Appl. No. 10/071,938  
Amdt. dated Aug. 19, 2005  
Reply to Office Action of Apr. 19, 2005

### REMARKS/ARGUMENTS

***FIG. 1***

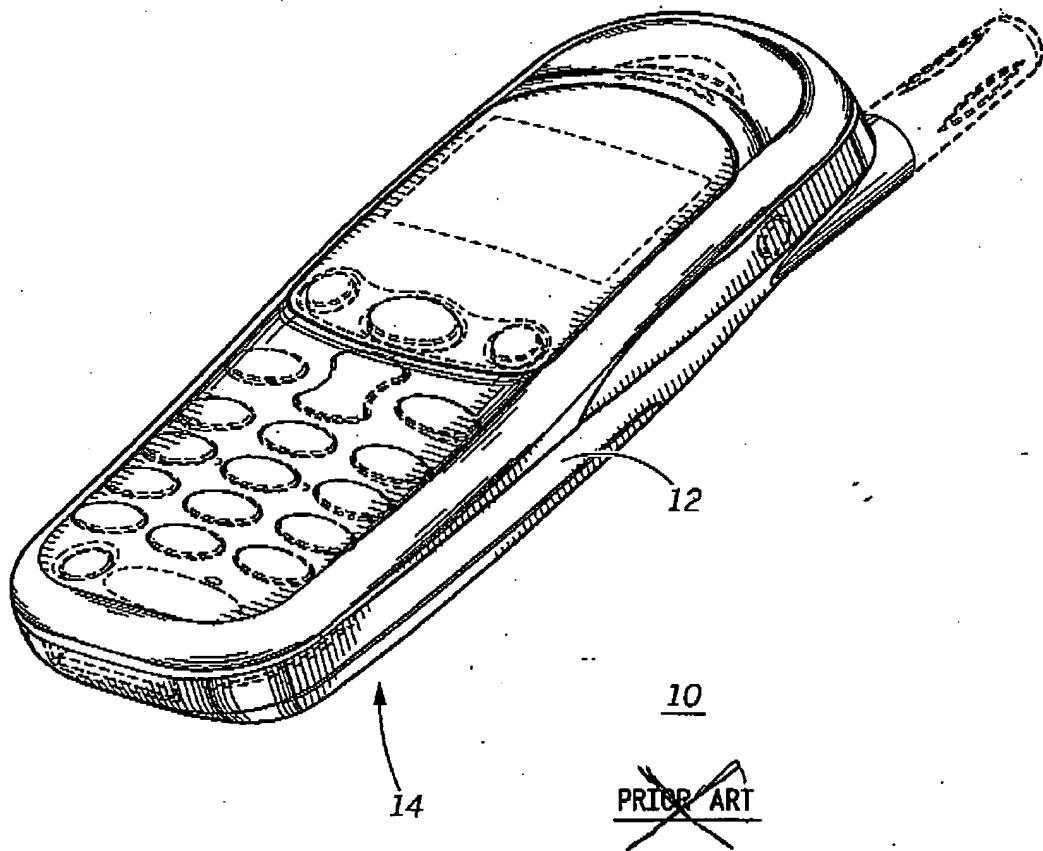
The attached sheet of drawings includes changes to FIG. 1. This sheet, which only includes FIG. 1, replaces the original sheet including FIG. 1. In FIG. 1, the term "PRIOR ART" has been deleted.

6. Applicants have amended FIG. 1 of the drawings to remove an inadvertent inclusion of the term "PRIOR ART." Applicants submit that all such drawing amendments are fully supported by Applicants' originally filed specification and, therefore, do not introduce any new matter into the specification.
